**UNITED STATES DEPARTMENT OF COMMERCE
Patent and Trademark Office**

Office Action Summary

09/496,467

BODKIN, LAWRENCE E

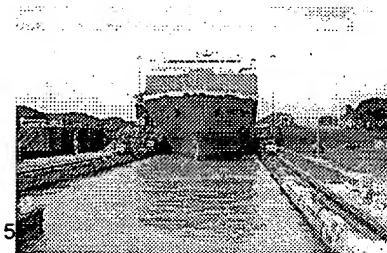
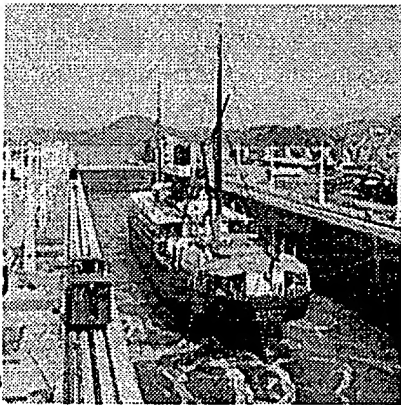
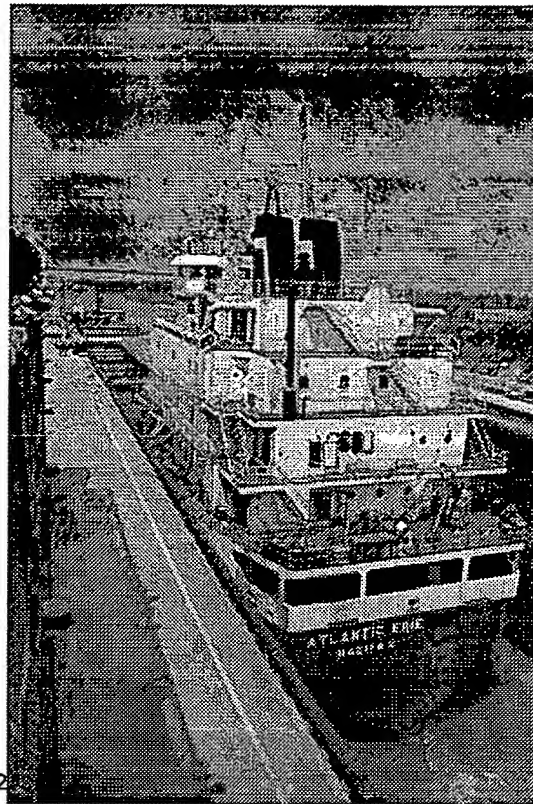
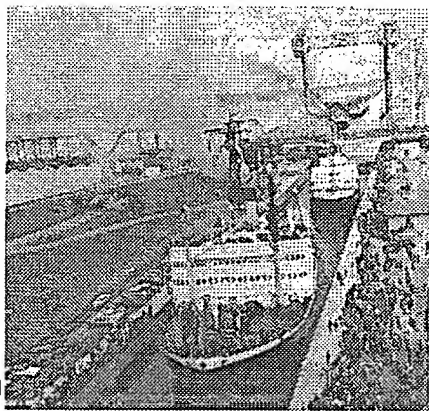
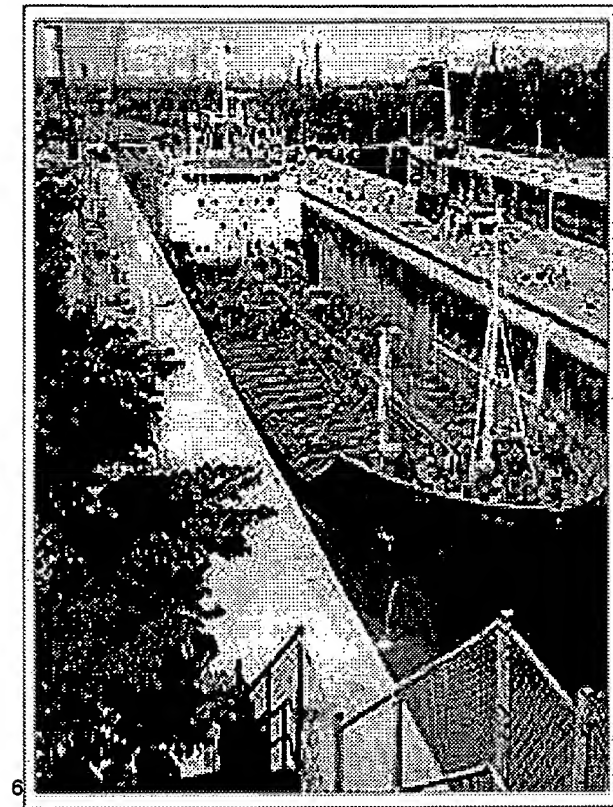
7. Claims 1-19 are rejected under 35 U.S.C. 102(b) as being anticipated by Omachi and the following six pictures.

Omachi and the above six pictures disclose a cavity that is made to hold liquid. The walls of the body are formed so they correspond to the shape of a body within the cavity. This includes horizontal walls that are closely spaced to the horizontal walls of the body and vertical walls that are closely spaced to the vertical walls of the body. The walls of the cavity and the body are also slightly sloped to further reduce the space between the walls.

Though not specifically disclosed or taught, the limitation that the liquid within the cavity exerting an upward force on the body that is greater than the weight of the liquid that it displaces and an equal to a volume of liquid that had the same volume as the object or that portion that is immersed is considered an inherent trait of the above canals and locks.
